Access Compliance Report

Public Rights-of-Way

(Pedestrian Signals)

Intersection ID: N/A	Main Street:	Cross Street: N/A	Location: N/A
ADA ID: 5A6F69D5F354	Signal Type: One Push Button-Non APS	Overall Compliance: No	Severity Score: BTN 1: N/A BTN 2: N/A No BTN: N/A
Codes/Mitigation Info/Possible Solution		Field Measurements/Component Compliance

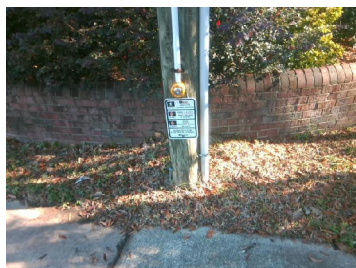
PROW/ADA: TMUTCD 4e.08, R404.2, R404.3, R406.2

Possible Solutions: Replace Signal Push Button With APS Button on New Post. Remove & Relocate Sign.
